**NO:** MS-020      **PRODUCT:** RS-232C Cable ZS-XRS2, ZW-XRS2  
**DATE:** April 2015      **TYPE:** Modification Notice

## RS-232C Cable for ZS and ZW Measurement Sensors Modified for Improved Operability: New Connector Screws

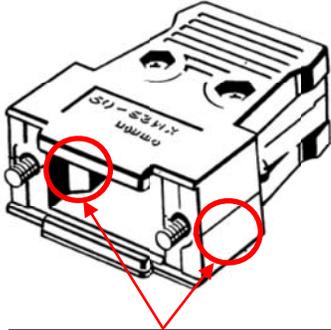
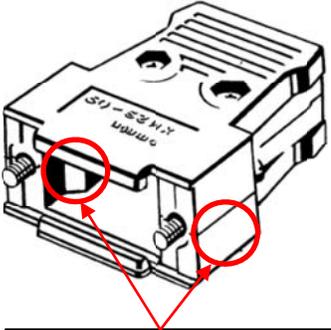
**Reason for Modification:** To improve connection reliability to DOS/V PCs.

Before the change	After the change
<p><b>Connector type</b>                      Model of connector: XM2S-0911</p>  <p>MM Screw: M2.6 X 0.45</p>	<p><b>Connector type</b>                      Model of connector: XM2S-0913</p>  <p>Inch Screw: #4-40UNC</p>
